DUKE POWER COMPANY  
DESIGN ENGINEERING DEPARTMENT

SQRT AUDIT RESOLUTIONS  
CATAWBA UNIT 1  
FOR  
SQRT AUDIT CONDUCTED  
MARCH 13-16, 1984

RESOLUTION SUBMITTAL DATE  
APRIL 17, 1984

CATAWBA NUCLEAR STATION  
SEISMIC QUALIFICATION OF SAFETY-RELATED ELECTRICAL EQUIPMENT  
RESOLUTION OF SQRT AUDIT ITEMS

FIGURE 4

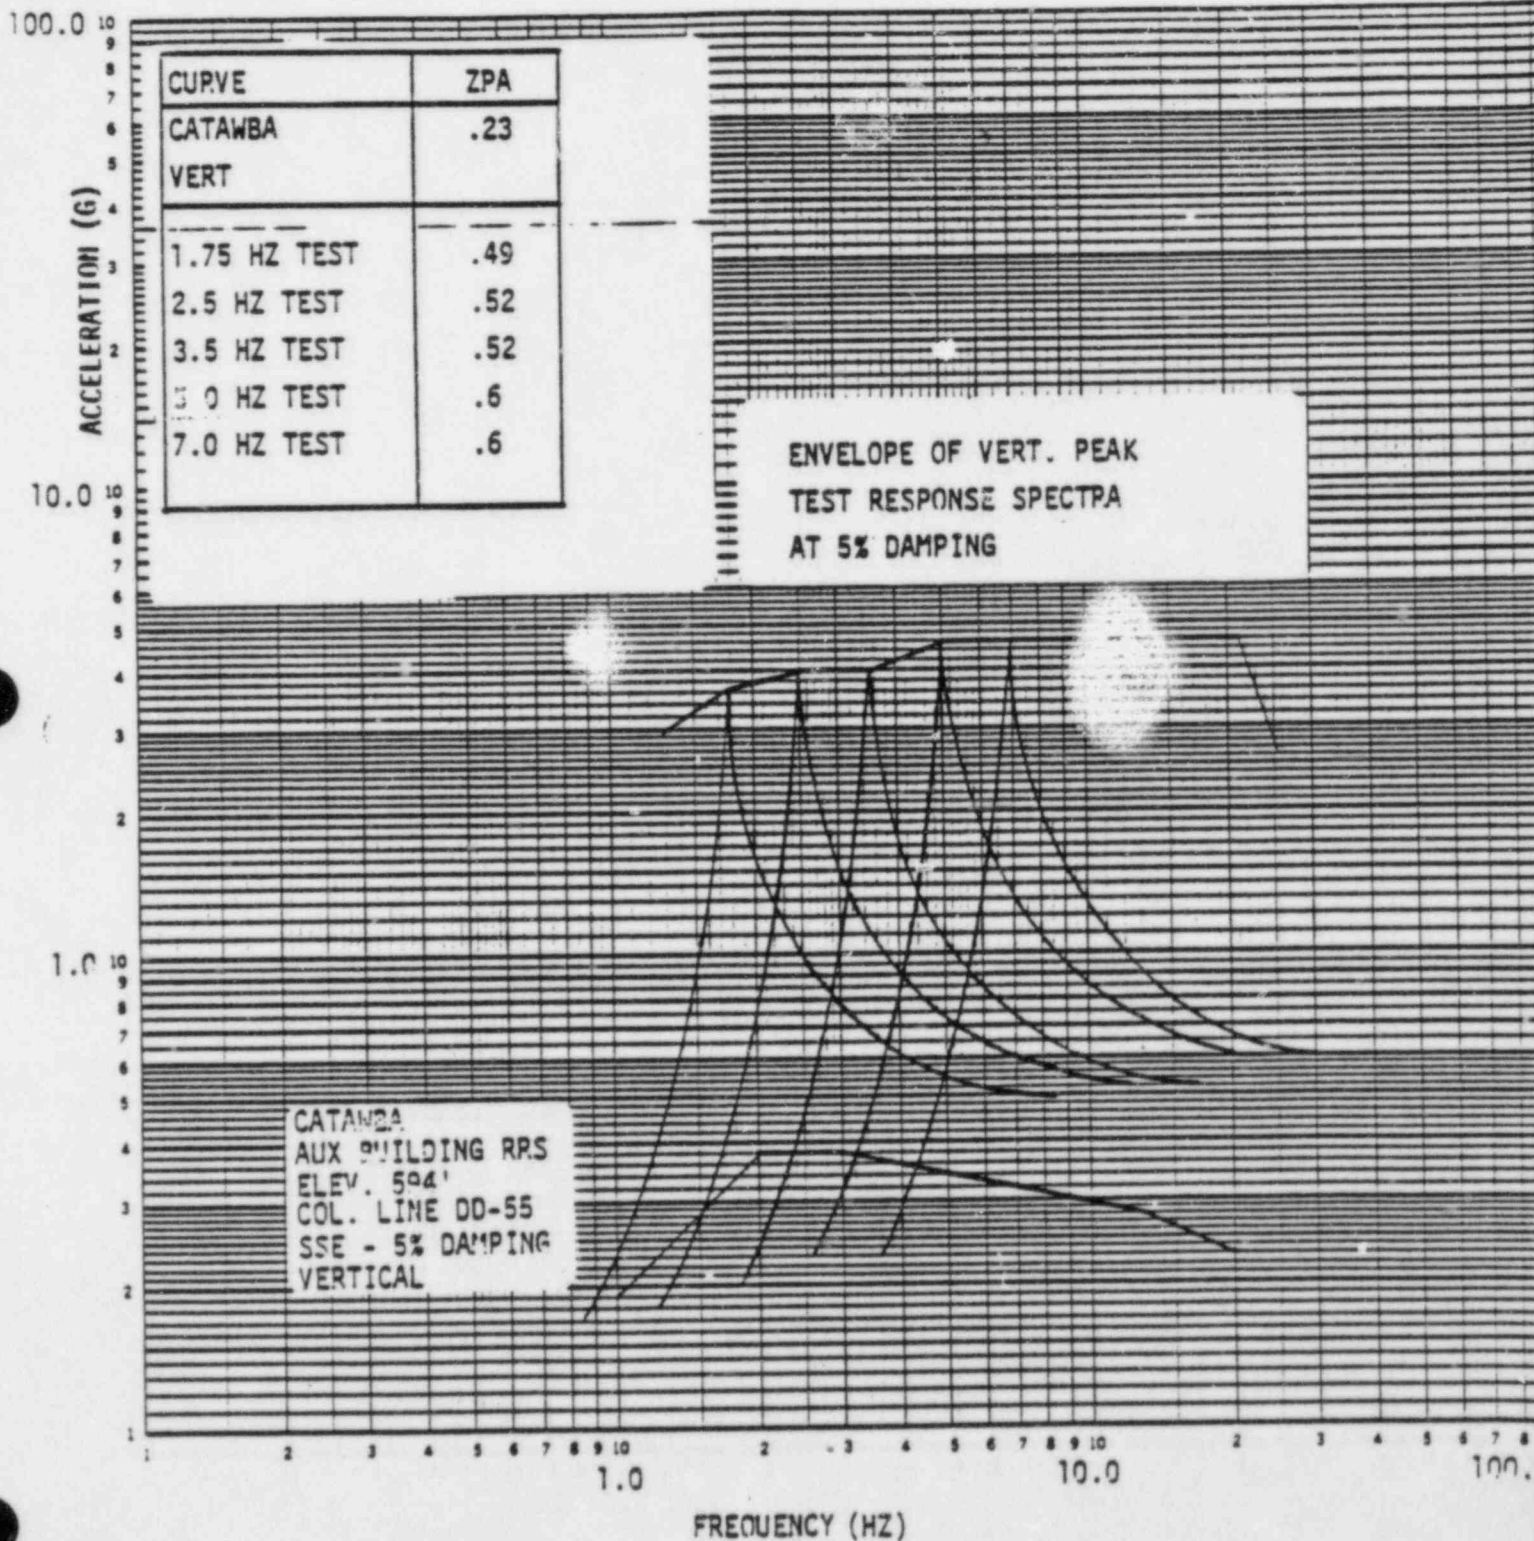
PART 1: Shim is required at bottom of cabinet to provide continuous contact.

RESOLUTION SUMMARY: The Unit 1 Engineering Safeguards Test Cabinet will be inspected and, if necessary, shims will be installed to provide continuous contact prior to fuel load.

Figure 1

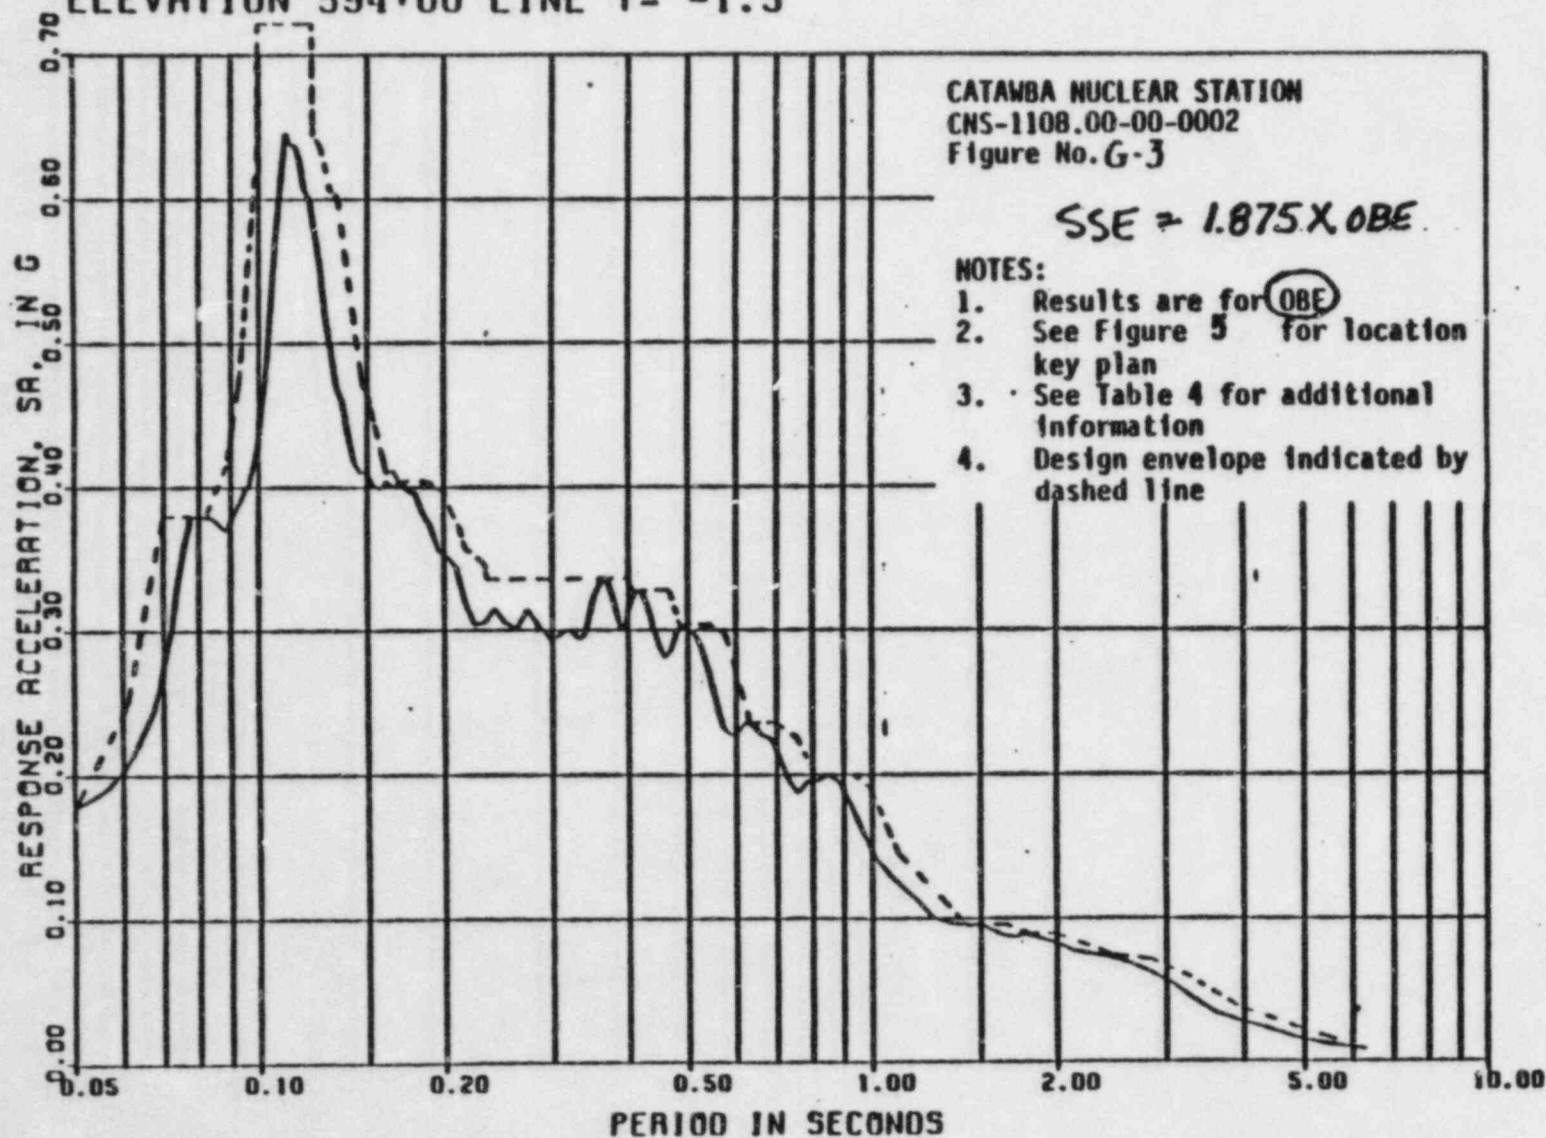
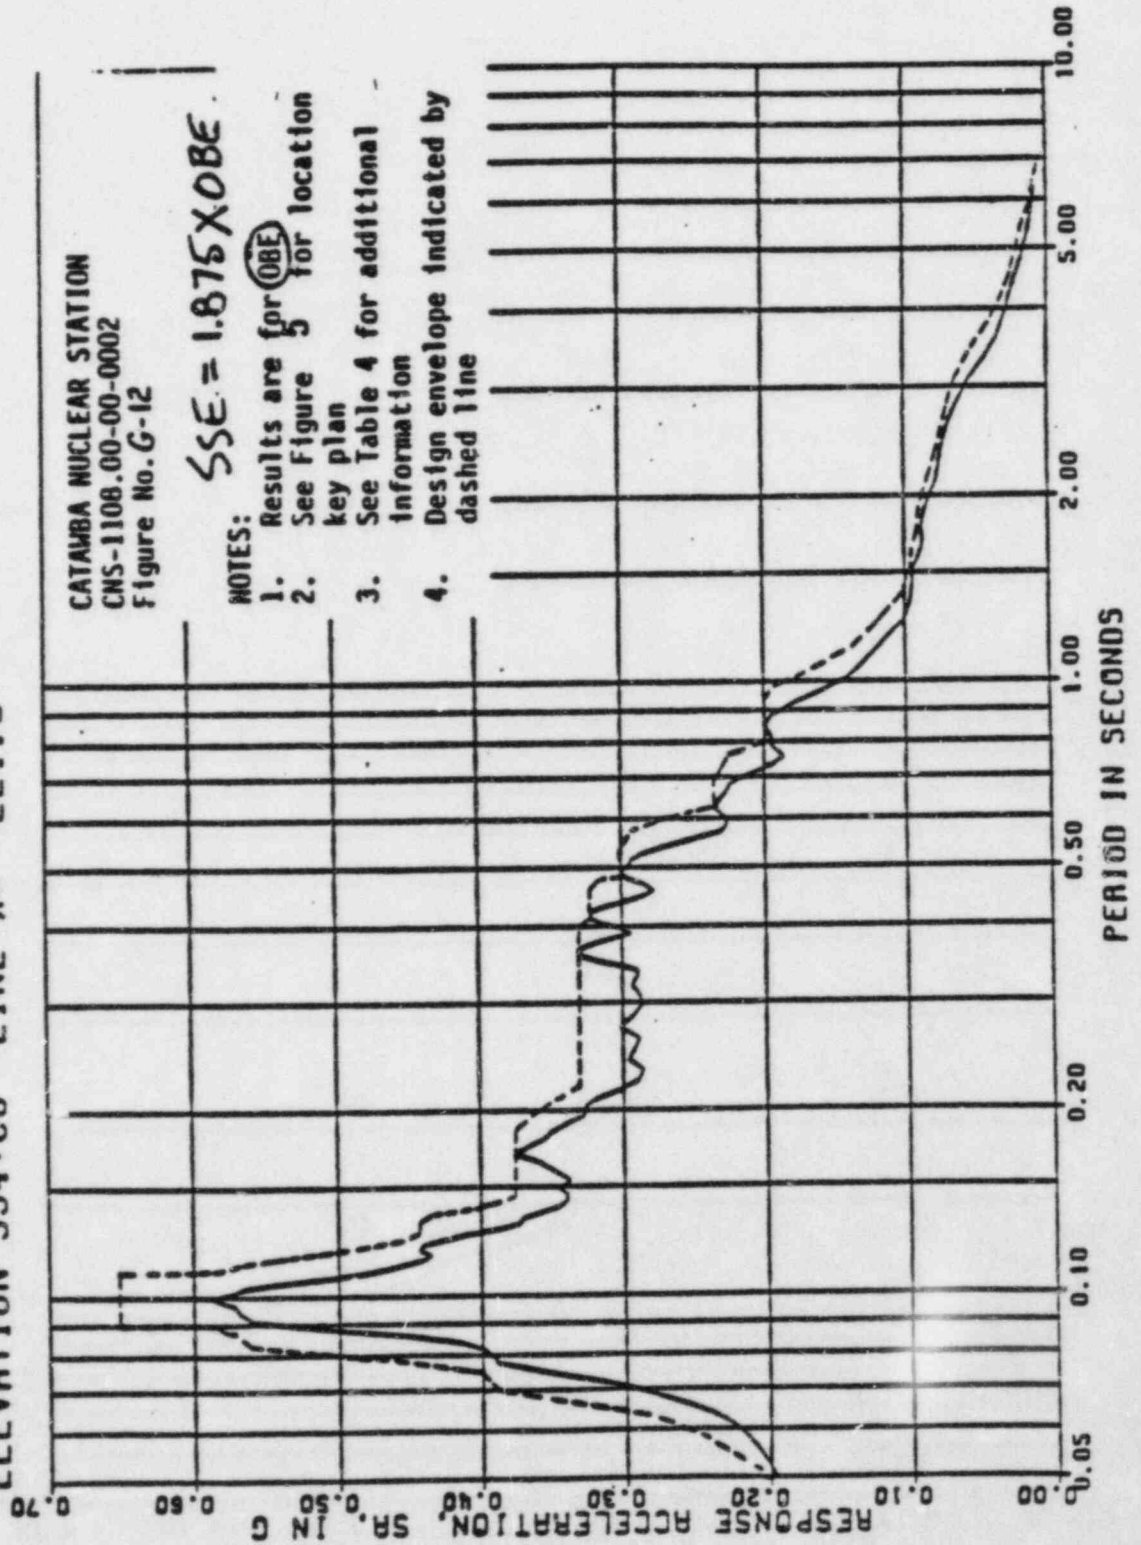
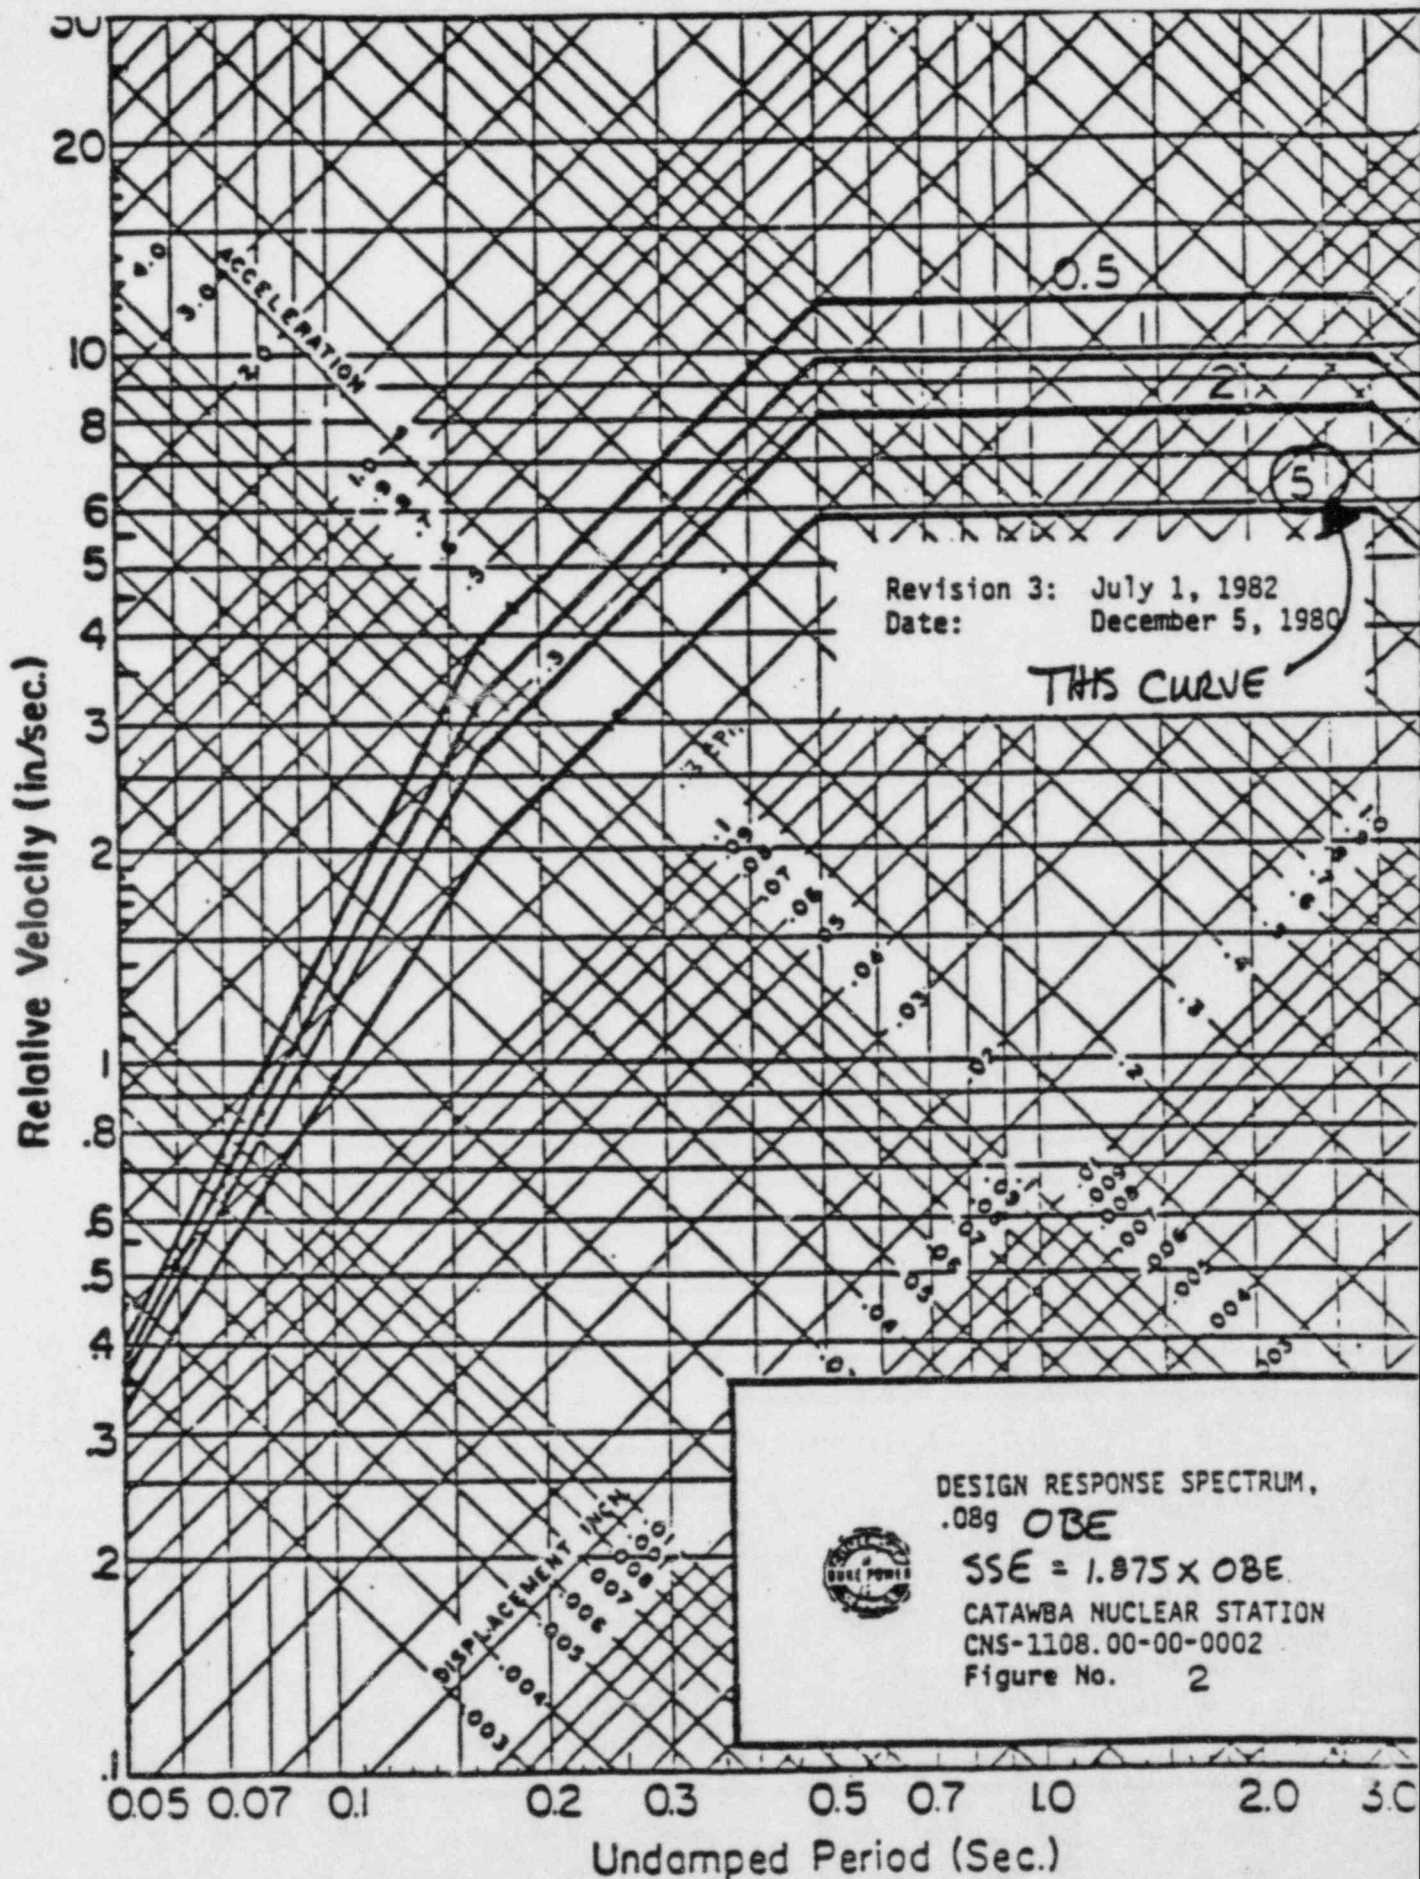
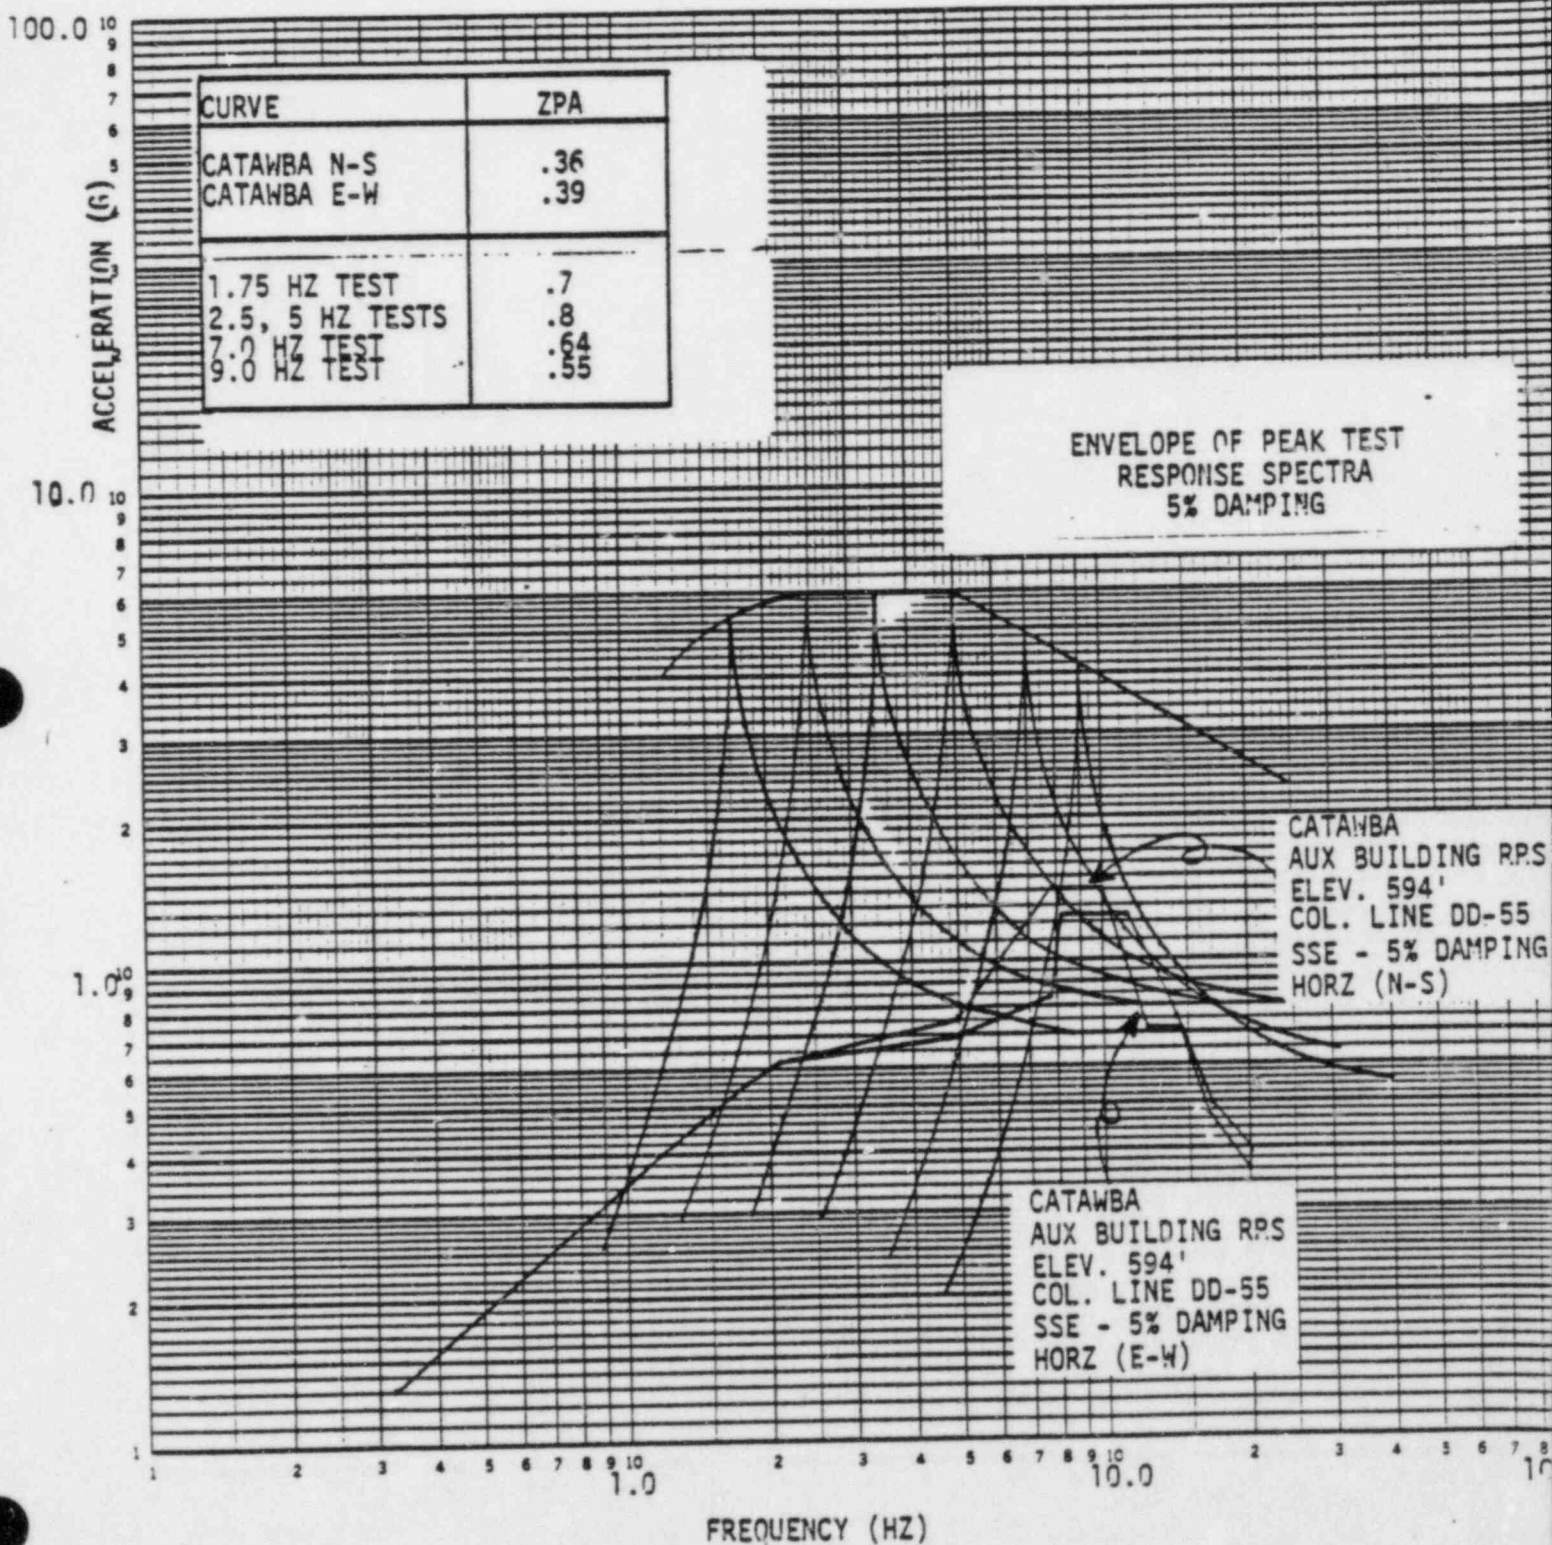
PART 1: There was no indication that this equipment was tested beyond 25 Hz. Westinghouse is to confirm that it was tested beyond 25 Hz or provide justification for this position.

PART 3: Provide an auditable link for qualification documents (i.e., qualified vs. installed).

RESOLUTION SUMMARY: At the time the seismic tests were performed and the WCAP 7817 written, 25 Hz was considered the upper frequency limit for testing (as noted in WCAP 7817 "Basis of Criteria," Page B-4). However, as a precaution against having to perform additional tests at higher frequencies at a later date, seismic tests were performed to an upper frequency limit of 35 Hz. During these added tests from 25 Hz to 35 Hz, no resonance frequencies were found and the sine beat acceleration was held constant at 0.2g. No mechanical changes in any equipment was observed and all electrical functions were normal during these additional tests. A record of the 35 Hz testing is in the Westinghouse detailed test data file.

RESOLUTION SUMMARY: A review of the SSPS furnished by Westinghouse was made with the view of selecting a standard SSPS for testing to establish criteria as stated in Section 1 of WCAP 7817. As a result, the SSPS tested was chosen as being representative of the SSPS supplied to Duke Power Company for the Catawba plant. Therefore, since this identified equipment was subjected to type tests under simulated seismic accelerations which envelope the Catawba specific seismic requirements, the Catawba equipment is qualified based on WCAP 7817 and the test data cited in Part 1 of this response. This response confirms the applicability of the testing in WCAP 7817 to the specific SSPS for Catawba, consistent with the requirements of IEEE-34-1971.
